Murray City Planning Commission Meeting
Notice of Meeting and Agenda

Thursday, September 4th, 2025

ITEM TYPE:	Design Review, Conditional Use Permit, and Preliminary Subdivision		
ADDRESS:	368 West Vine Street	MEETING DATE:	September 4 th , 2025
APPLICANT:	Adam Maher	STAFF:	David Rodgers, Senior Planner
PARCEL ID:	21-12-177-009	PROJECT NUMBER:	25-010 & 011
ZONE:	MCMU, Murray Central Mixed Use		
SIZE:	.20-acre site 5,201 ft ² building 4 units / 682 ft ² of commercial space		
REQUEST:	The applicant is requesting Design Review and Preliminary and Final Subdivision approval to allow the development of a mixed-use project.

SHEET NUMBER: A201

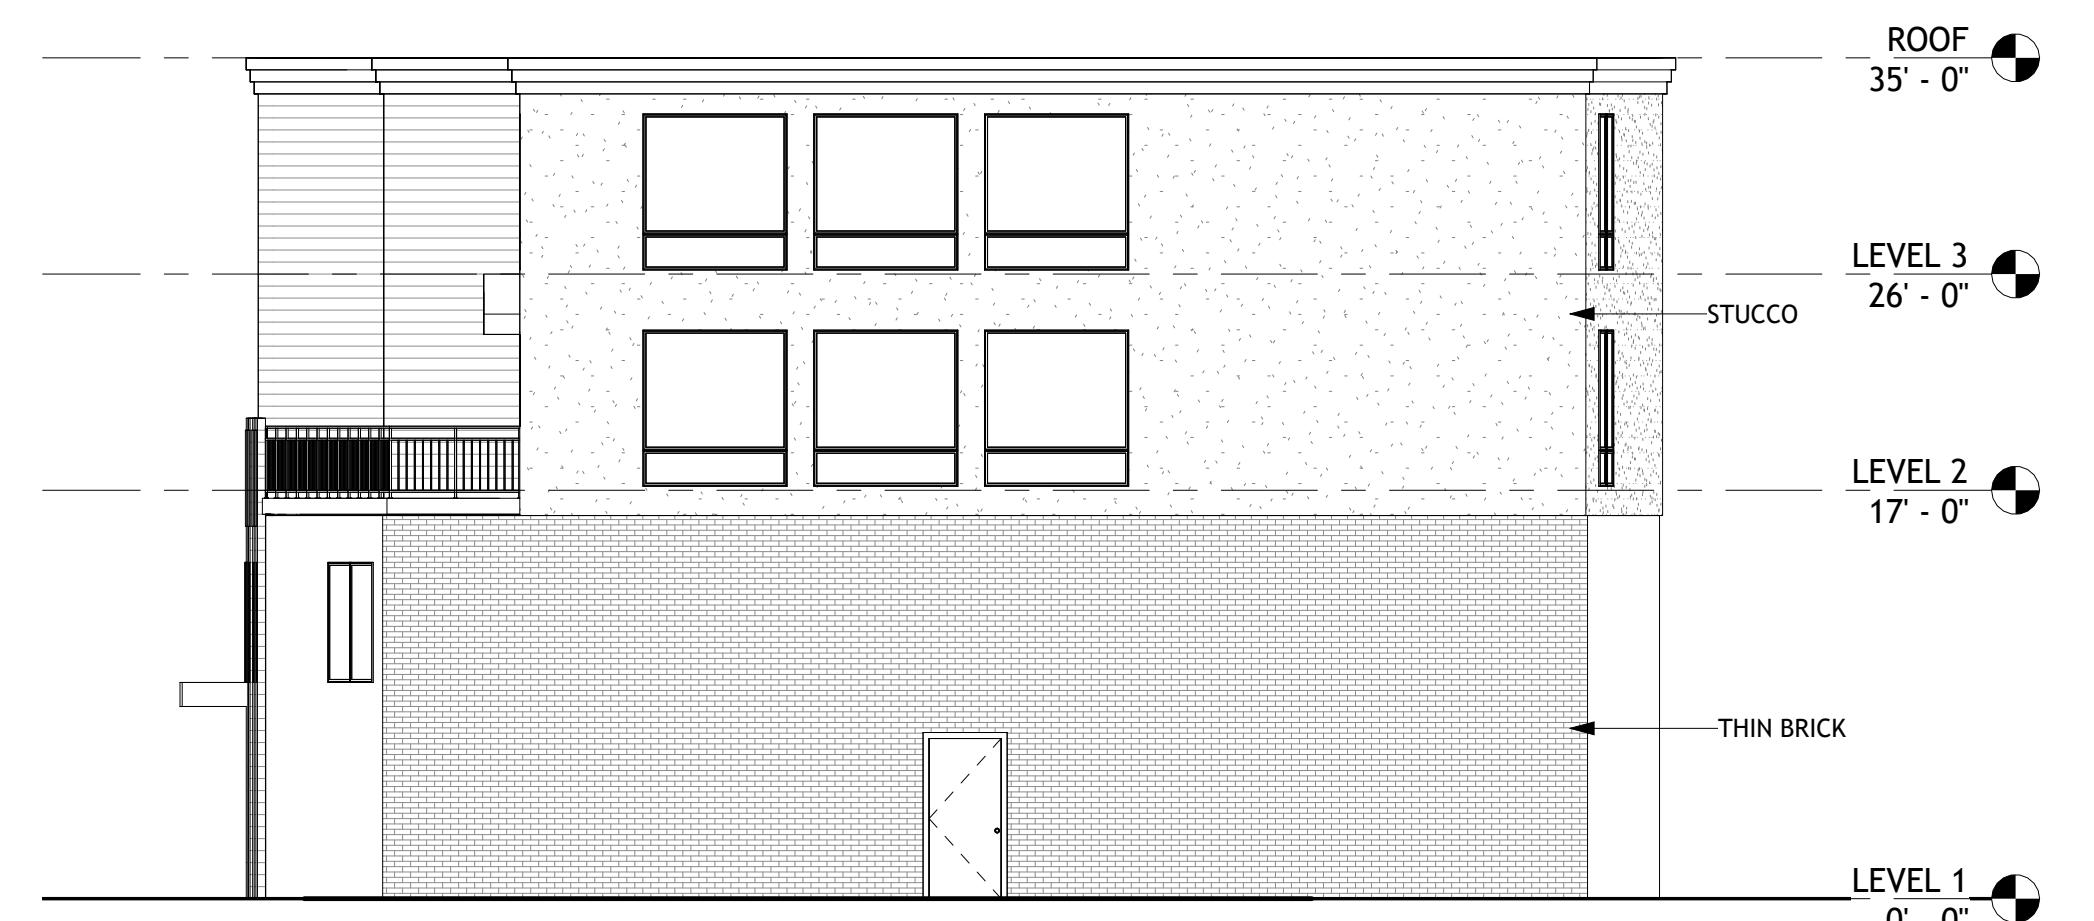
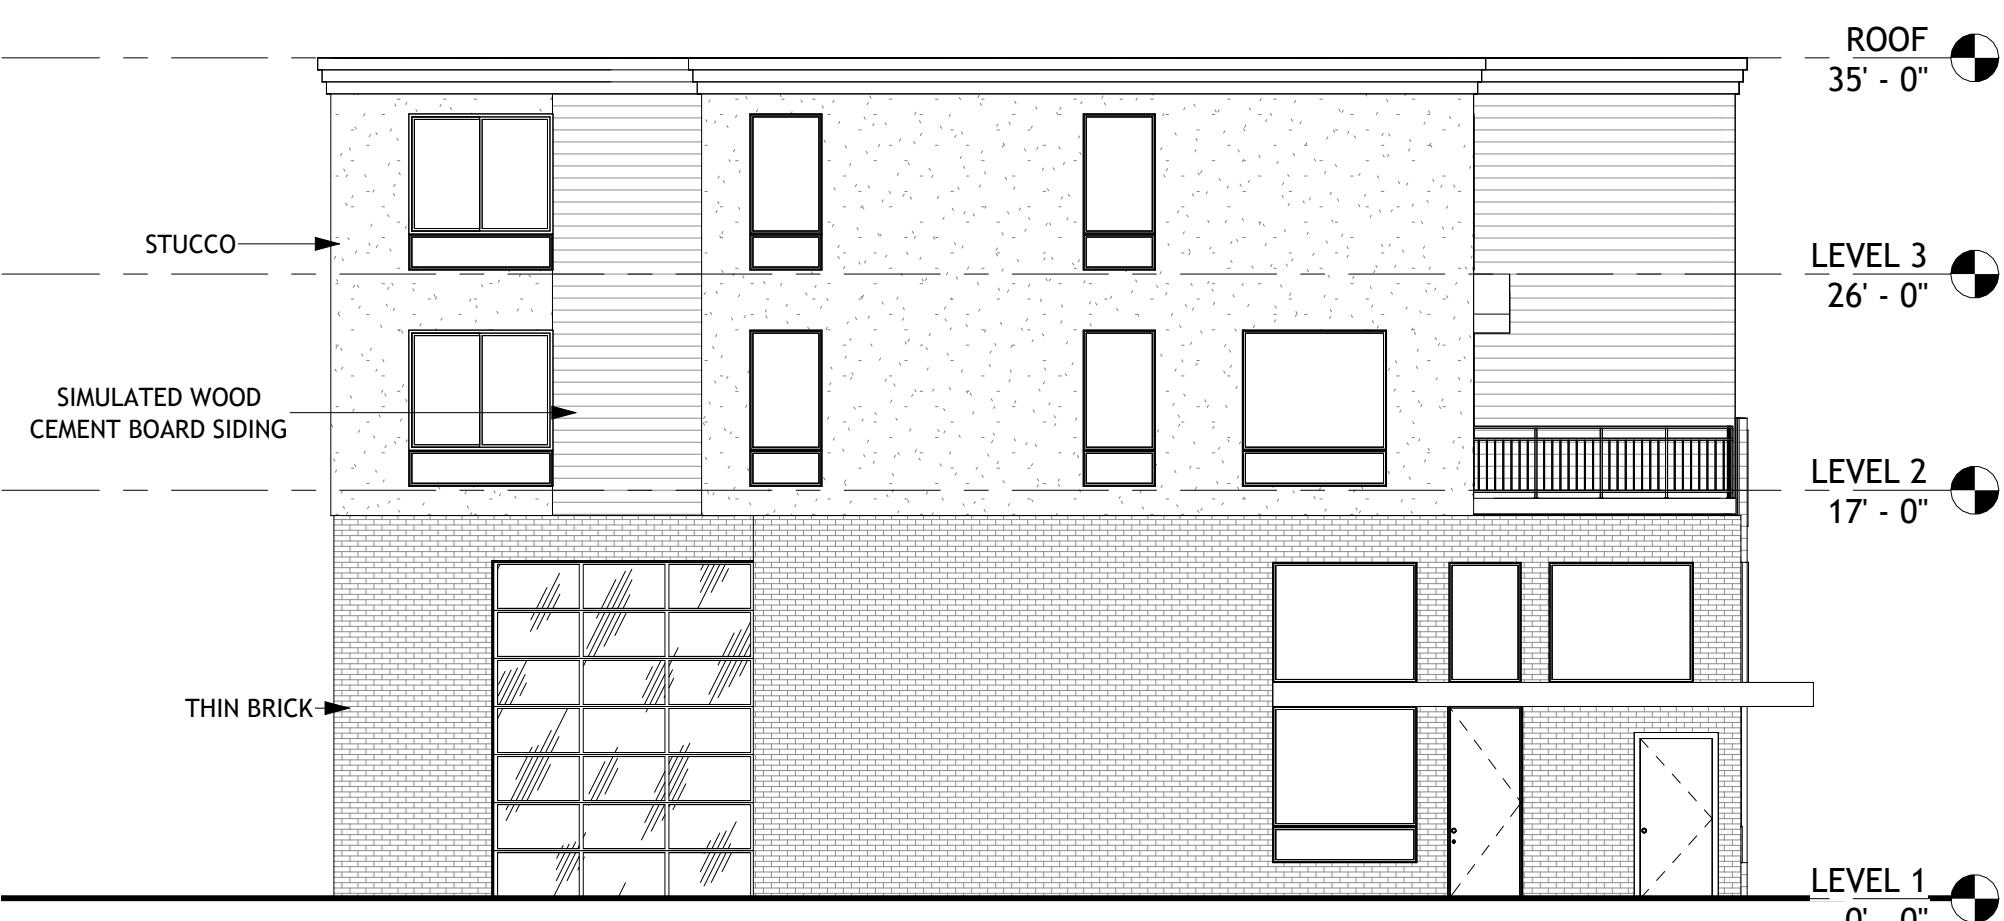
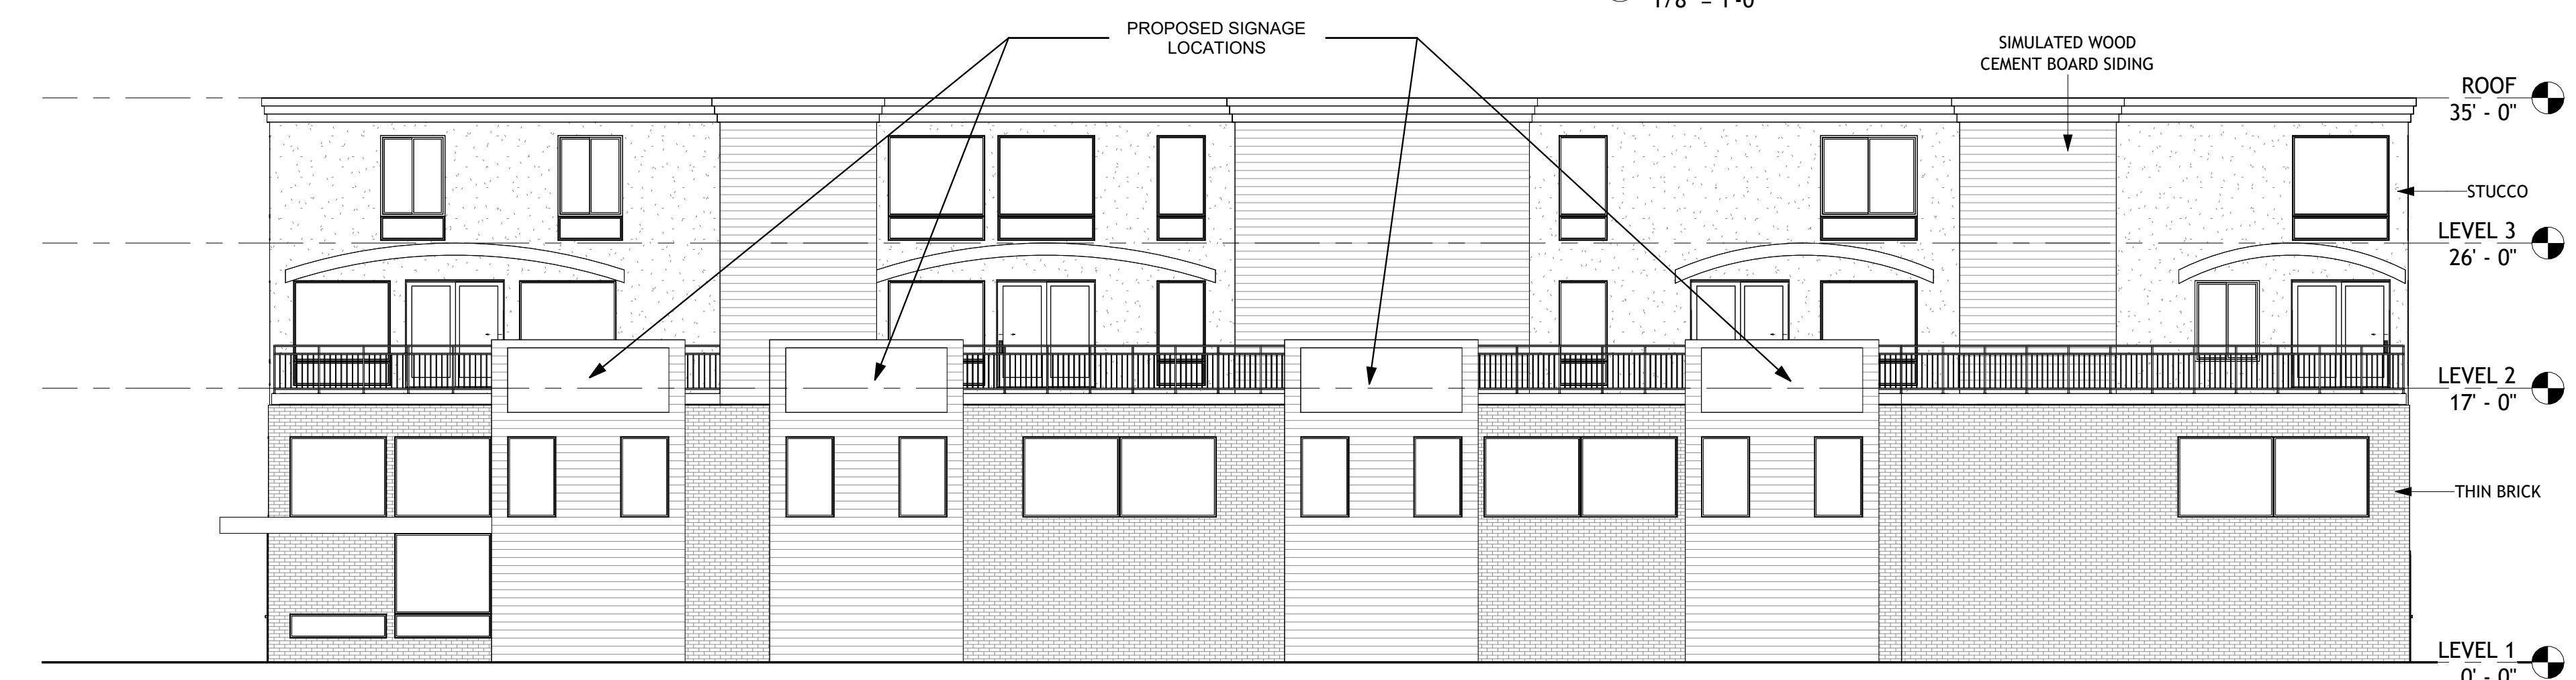
Elevations of the buildings have been attached to this report for review. The building will be flat roofed, with varied architectural features on all elevations generally. Materials will include cement board siding, brick, and stucco with several accents. The Planning Commission has discretion to determine whether they feel the materials meet the intent of the ordinance.

MURRAY BLOCK ONE SUBDIVISION

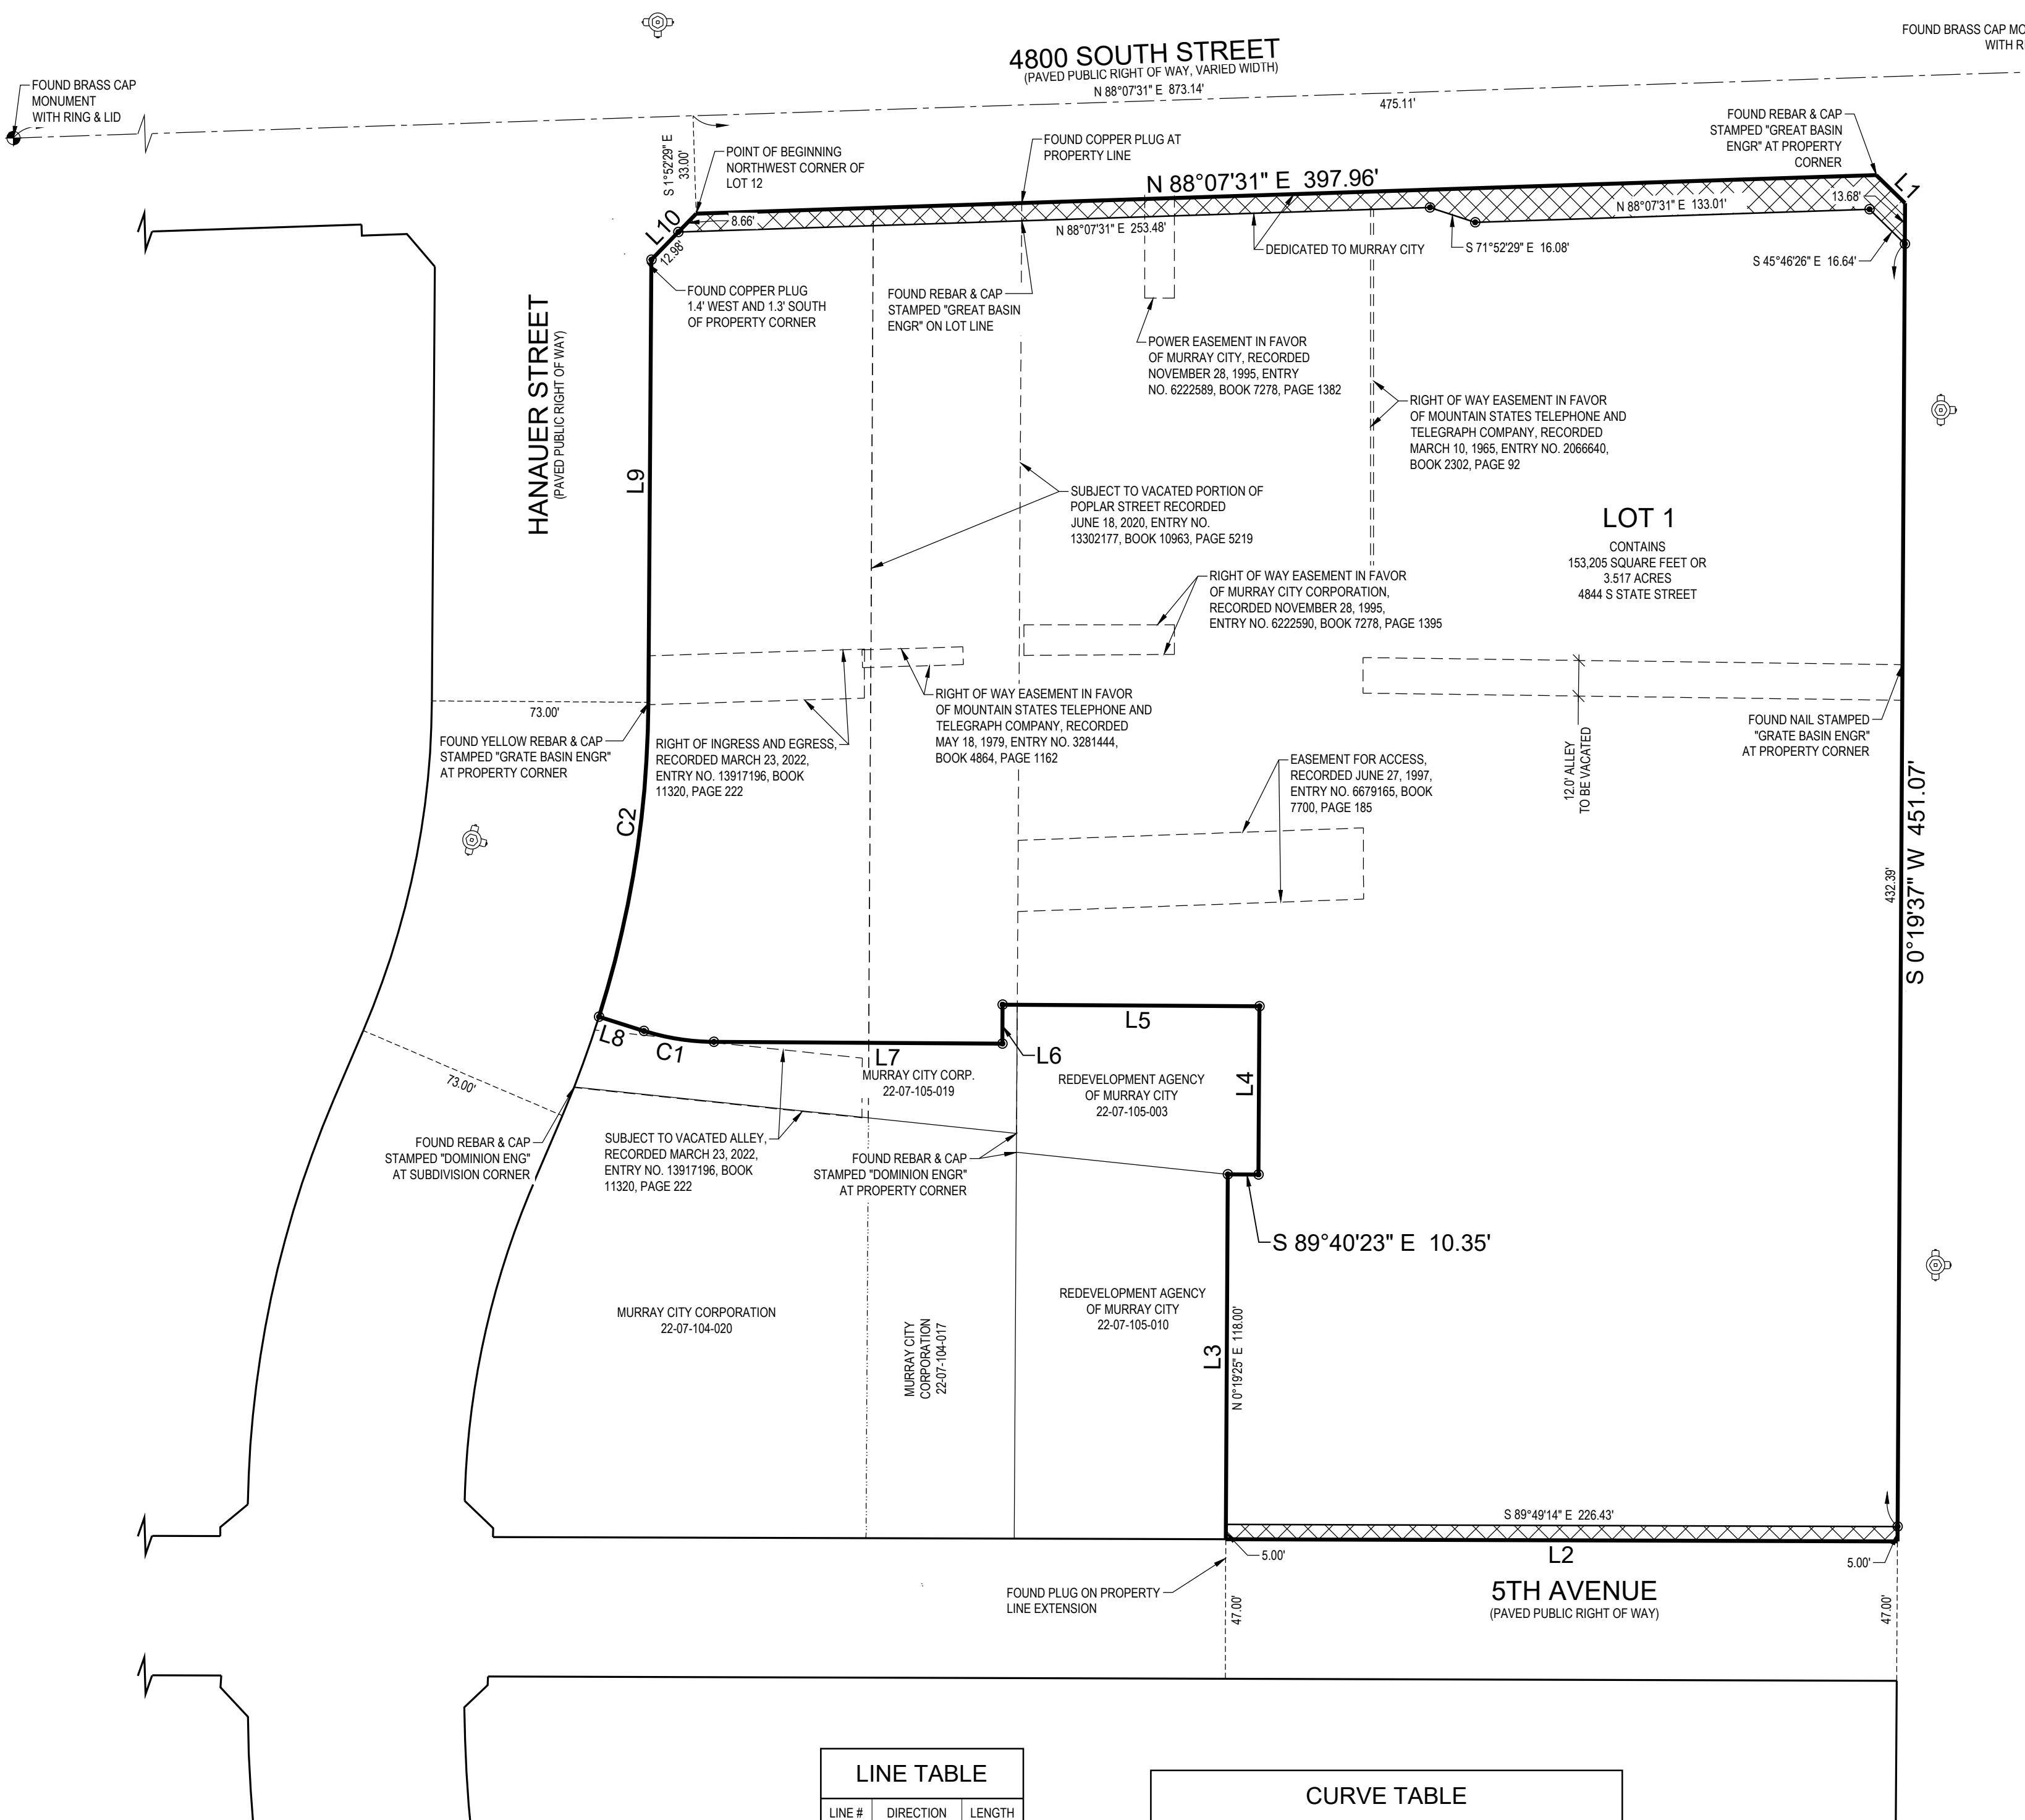
- The 12' Alley must be vacated prior to recording the plat.
- Provide an access easement on the southwest side of the property from Hanauer Street.
- Provide dedication for 4800 South widening.

- Vacate unused and unnecessary easements shown on the plat – relocate or abandon utilities as required.
- The plat must provide the correct Ownership and Acknowledgements for the signers. There are currently three property owners within the plat boundary.

- Provide conveyance deeds prior to recording the plat.
- Include standard utility notes and signature lines for utilities – Enbridge Energy requires their own note and signature line.

- Provide correct signature blocks and format.
- Address all City and County comments prior to printing the plat to mylar.
- The Murray Sewer Department stated the following:
